**EN 14491:2006/AC**

## Dust explosion venting protective systems

This corrigendum becomes effective on 19 November 2008 for incorporation in the three official language versions of the EN.

Replace Figure A.3 with the following figure: "

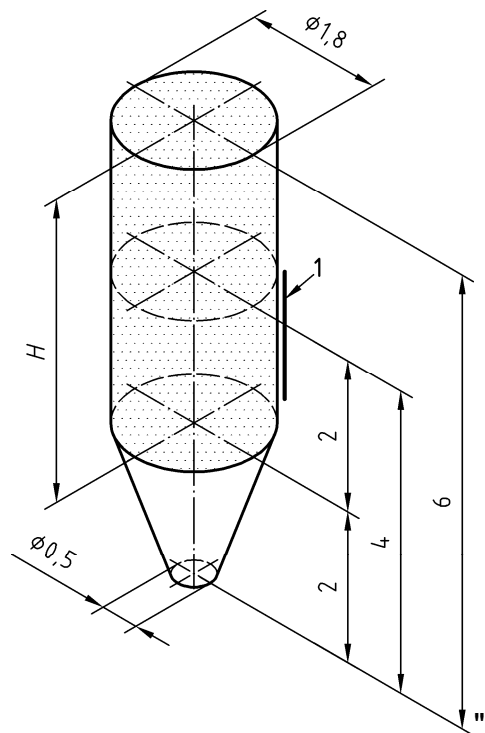
## 5 Modification to Annex A, Estimating the L/D ratio when calculating vent areas for elongated enclosures
